County of Fairfax, Virginia

STAFF REPORT ADDENDUM

SPECIAL EXCEPTION APPLICATION SE 2009-LE-001

APPLICANT: Nazir A. Bhagat and Ashraf N. Bhagat

DATE	BY	REVISION	APPROVED BY	DATE	BY	REVISION	APPROVED BY	DATE
SPECIAL EXCEPTION PLAT WALHAVEN WOODS PLAT OF SPECIAL EXCEPTION FAIRFAX COUNTY, VIRGINIA CL-2 DATE: OCTOBER 2008								
SHEET OF FILE NO. MISC 1734

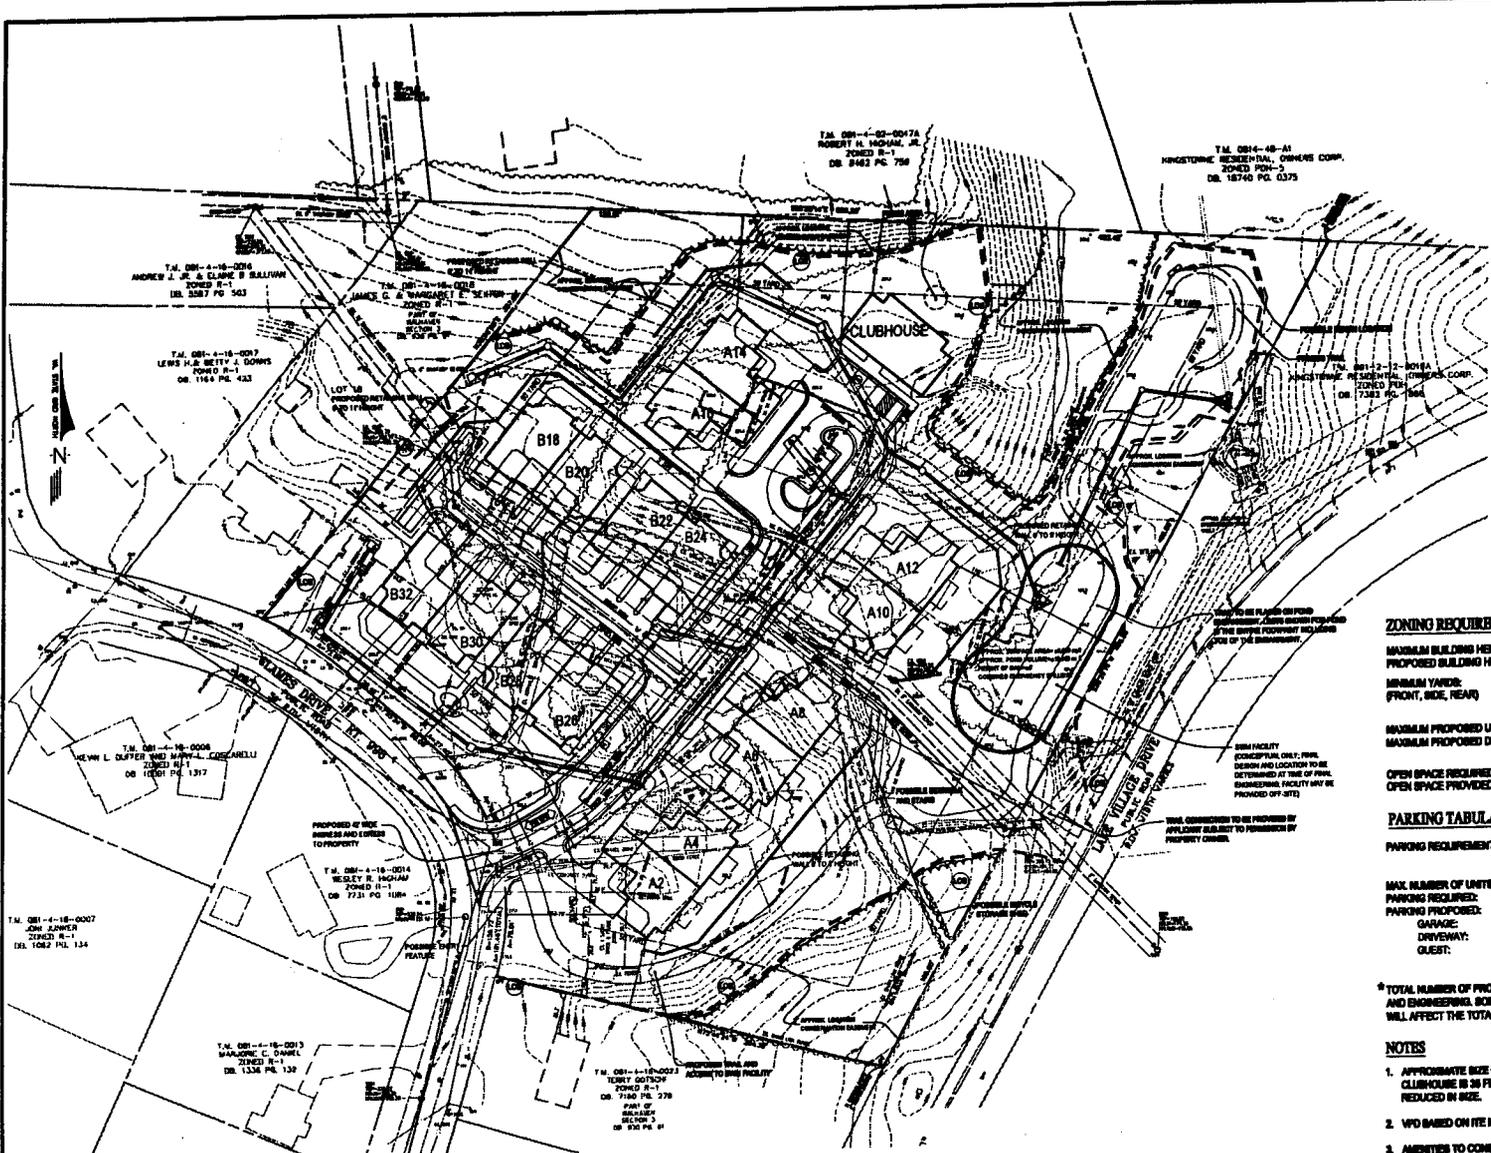
- The SE Plat no longer depicts vehicular access from Lake Village Drive to the proposed stormwater management pond in the eastern portion of the site. Vehicular access for pond maintenance is now shown from Clames Drive via a 12-foot wide proposed combined asphalt trail and pond maintenance access trail.
- The SE Plat now shows an additional outfall pipe extended from the northern portion of the stormwater management pond to the northeastern boundary of the site to provide outfall to the existing offsite stormwater

- The proposed trail which was previously shown along the eastern boundary of the proposed stormwater management pond has been relocated and the SE Plat now depicts a 12-foot wide trail on the pond embankment.
